K17	BT00.00-X-1000Z	Technical modifications	28.6.99
------------	-----------------	--------------------------------	----------------

L17 BT18.00-P-0001-01A	Oil spray nozzles for cooling piston crowns modified	Engines 604, 605, 606	 BT
-------------------------------	--	-----------------------	---

Production breakpoints/modifications/new features

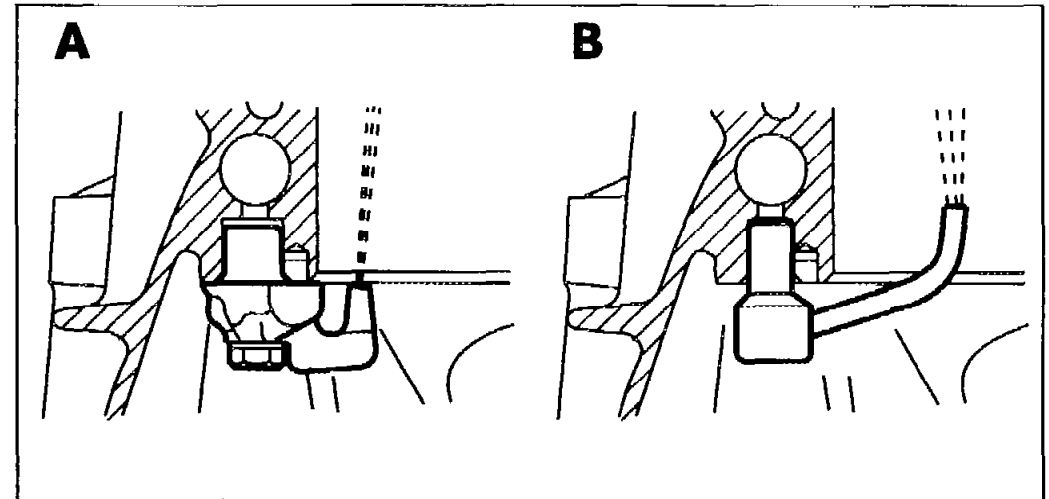
Modified oil spray nozzles

The oil spray nozzles for cooling the piston crowns (made of sheet steel) are interference-fitted into the connection ports to the main oil gallery, previously screwed-in (die-casting).

- A Previous version (screwed-in)
- B Present version (interference-fit)

P18.10-0253-01

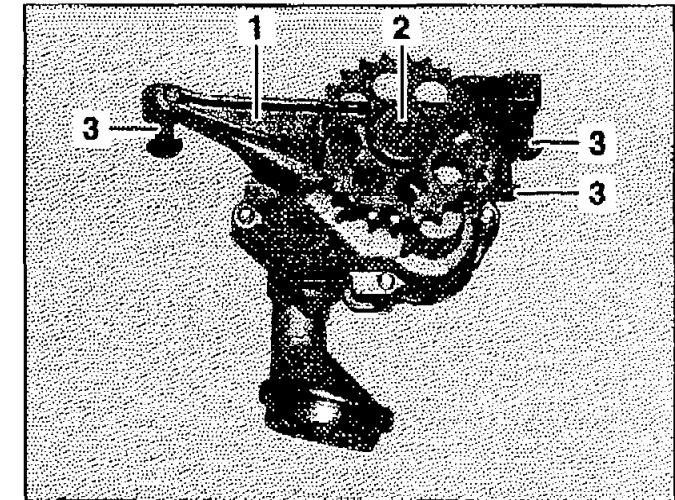
As of approx. 08.97 a modified oil pump has been fitted to the engine stated above.

The oil pump drive gear (2) is pressed on.

The oil pump (1) is fixed at the crankcase by three torx fit collar bolts (3) which have a modified tightening torque.

The front dowel sleeves are no longer fitted.

**The oil pump must only be attached to the crankcase using the fit collar bolts (3).**

P18.10-0254-01

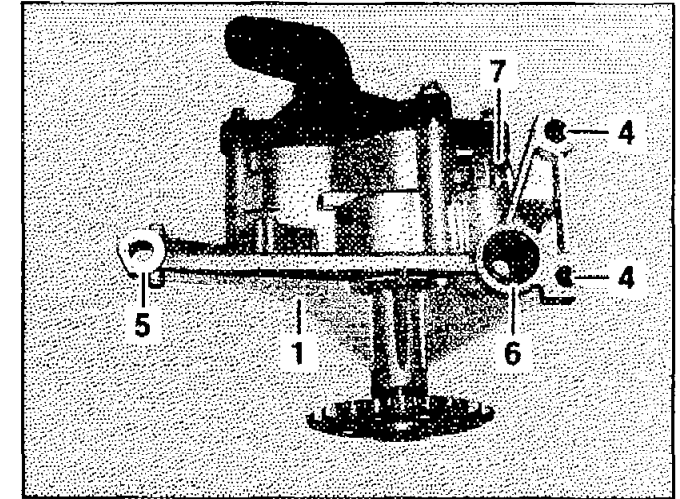
The left front hole (4) is a fit hole, the right front hole (5) has a slot.
The oil pump (1) is sealed to the crankcase by means of an O-ring (6).
The screw plug for the oil overpressure valve is replaced by a metal cover with circlip (7).
The oil overpressure valve cannot be removed.
